**Bid Title: RSA Grading and Runway Marking Replacement at Jack Brooks Regional Airport**  
**Bid Number: IFB 12-024/KJS**  
**Addendum No. 1**  
**To Plans, Contract Documents and Specifications**

RSA Grading and Runway Marking Replacement  
Jack Brooks Regional Airport

**To:** Potential Bidders **Date:** July 18, 2012  
**From:** Thomas D Dodson, PE  
**RE:** Jack Brooks Regional Airport – RSA Grading and Runway Marking Replacement  
Bid Number 12-024/KJS  
Bidder Questions

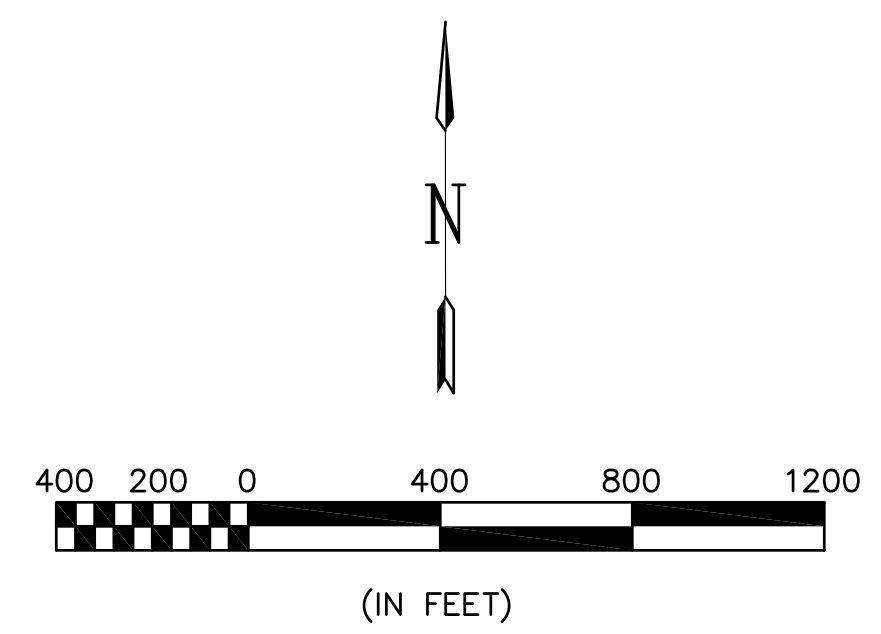
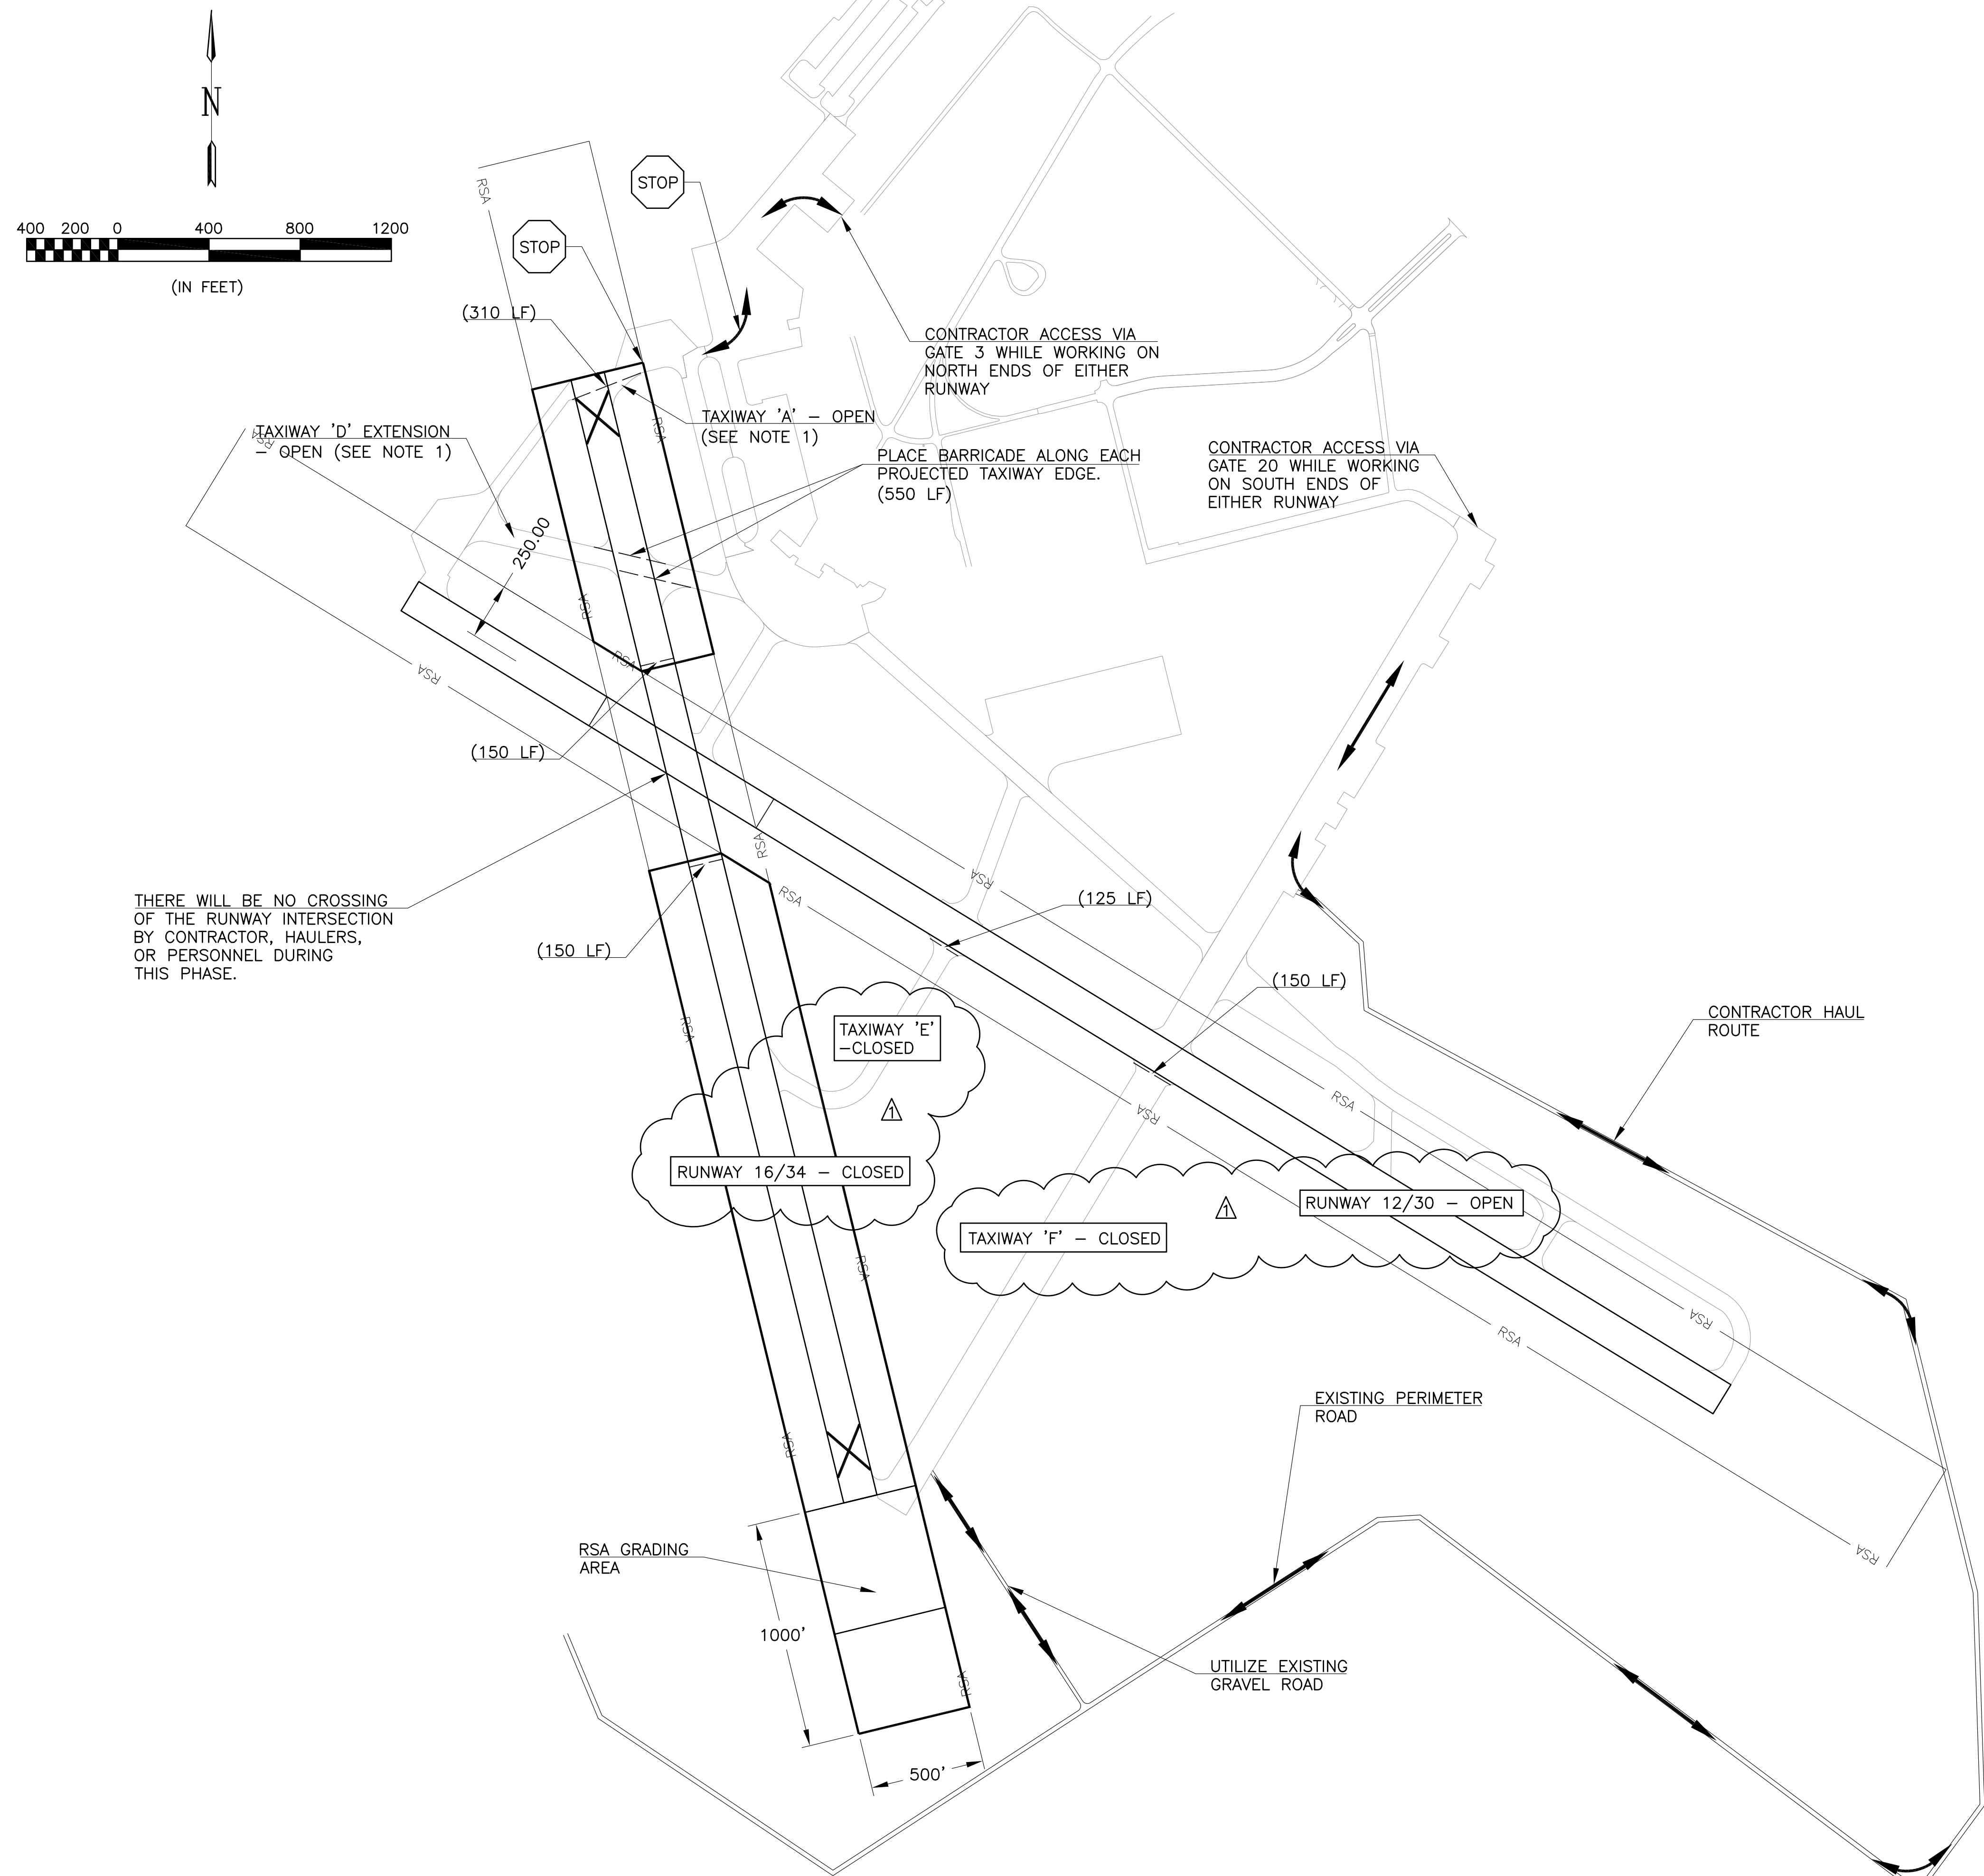
**Question 24:** Chart shows species for planting between January 15 and May 15. Does this remain the same if planted earlier?

**Answer:** See addendum No. 1 for a revised seed mix table.

ITEM T-901 SEEDING is hereby amended with respect to the paragraphs and sections cited below.

**Add the following to Section 901-2.1:**

**For seeding during the period May 16 to January 14 inclusive, add 30 pounds per acre pure live seed of Winter Rye, unless otherwise approved by the Engineer.**
